*ENVIRONMENTAL
IMPACT REPORT
FOR
CRUMMER SITE
SUBDIVISION*

SCH NO. 2008091155

CITY OF MALIBU

3. Response to Comments

Draft EIR Fig. 5.1-5

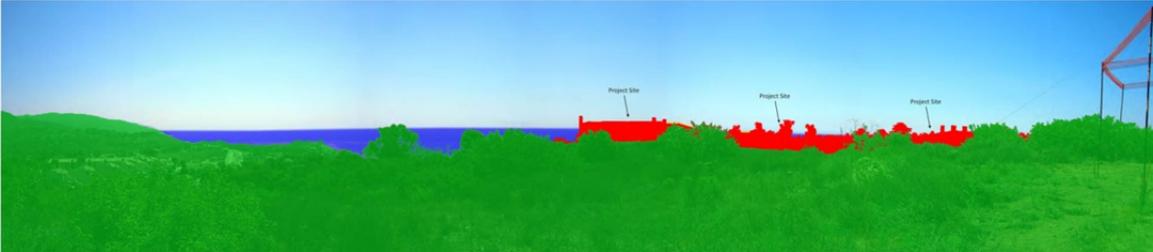
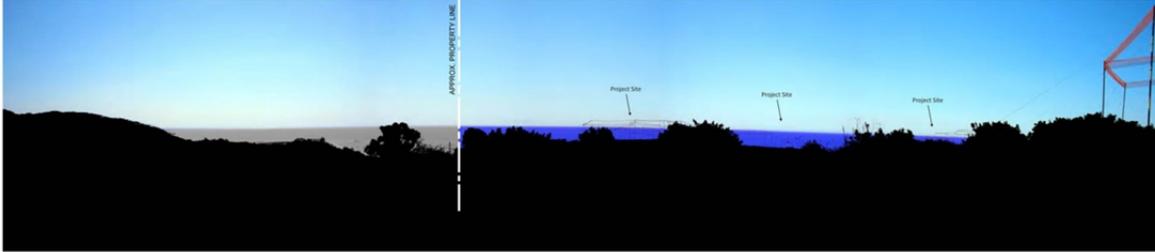
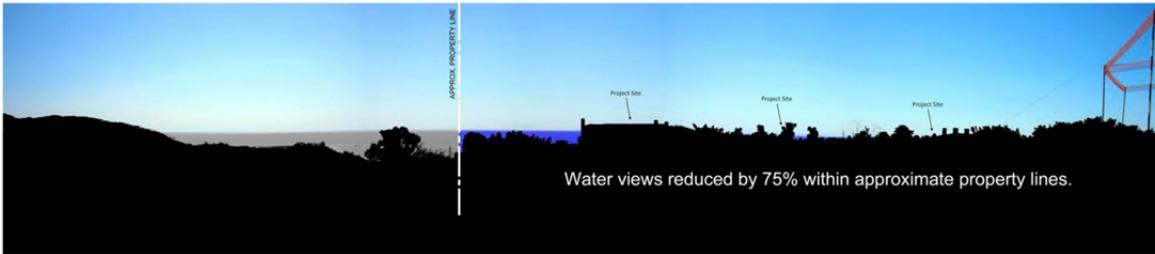
My client is proposing an Ocean view Resort Hotel. These impacts and blockage of the “blue water views”, will significantly compromise the eventual success of my client’s project. The Crummer project is also inconsistent with City and State rules and regulations associated with aesthetic impacts to the environment. | R9-13

The Planning Center | DC&E • Figure 3-8

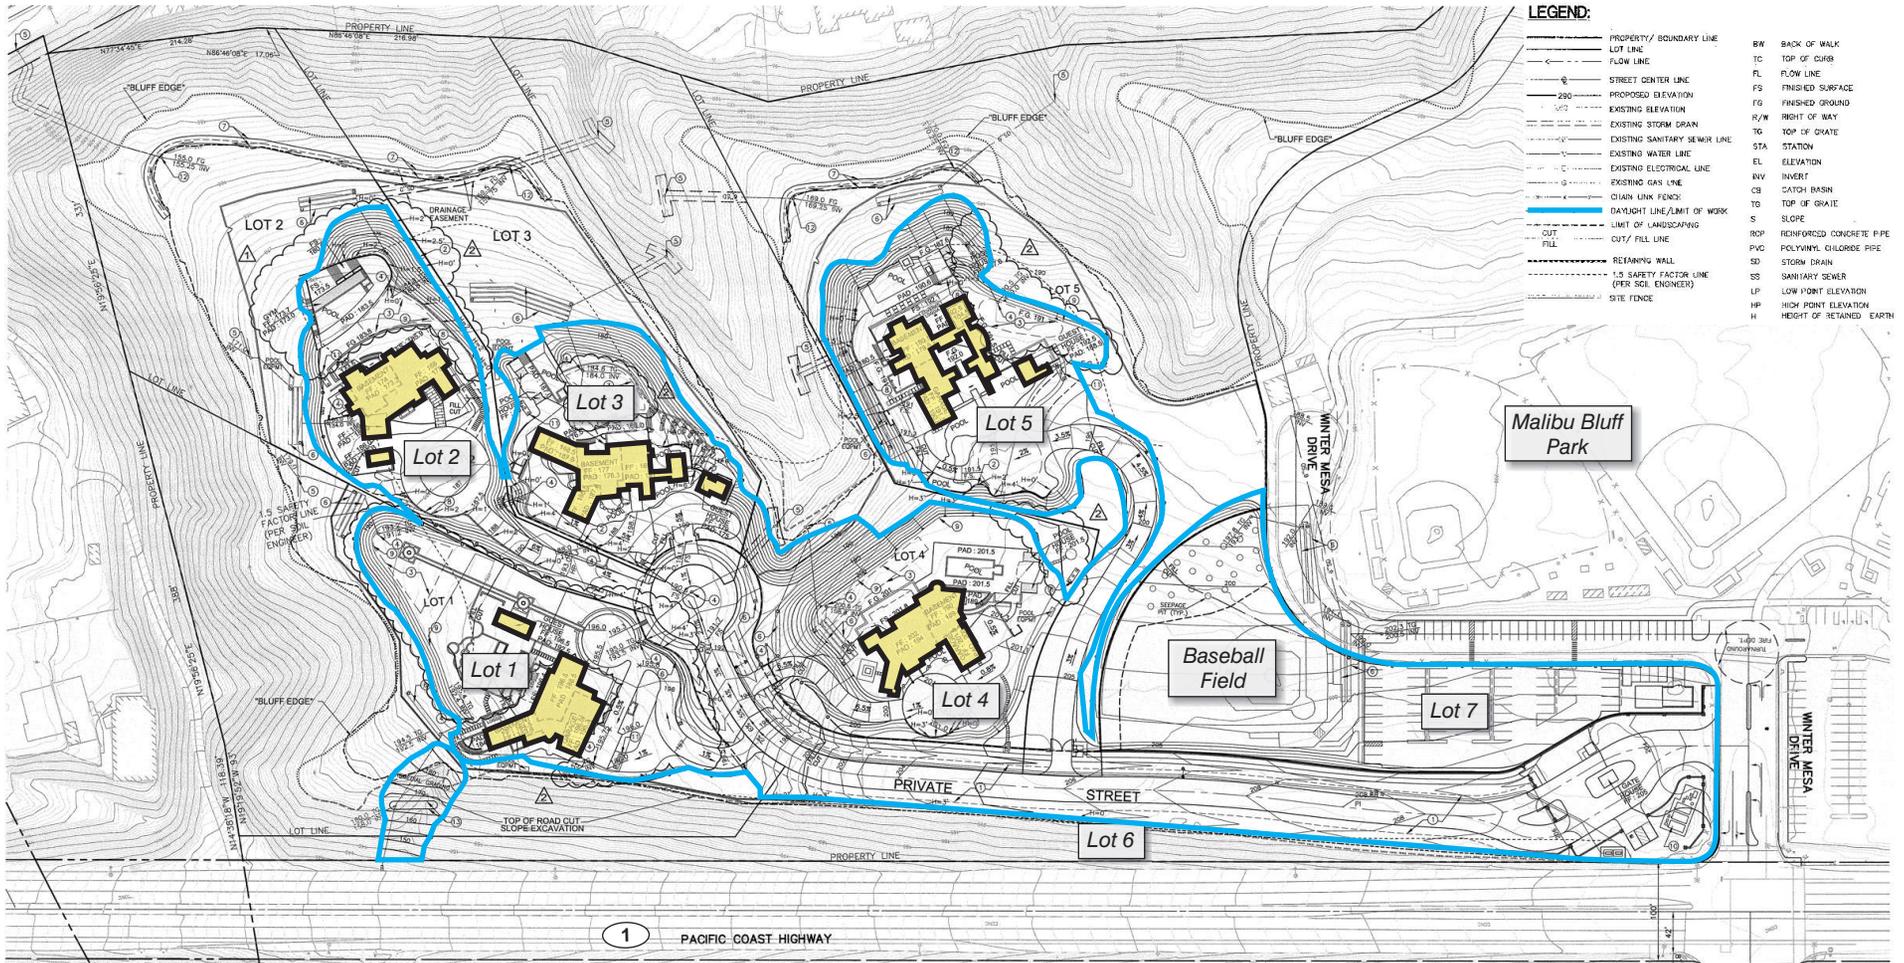
- b. **Figures 3.8 and 3.9-** The blue line denoting the “daylight line/limit of work” on Figure 3.8 should be extended to include all of the improvements on Lot 6. For consistency, the blue line indicating the “daylight line/limit of work” on Figure 3.9 should also be shaded blue.

Figure 3-8 *Grading Plan with Baseball Field Option* and Figure 3-9 *Grading Plan with Skate Park Option* have been revised to indicate the daylight line/limit of work as follows:
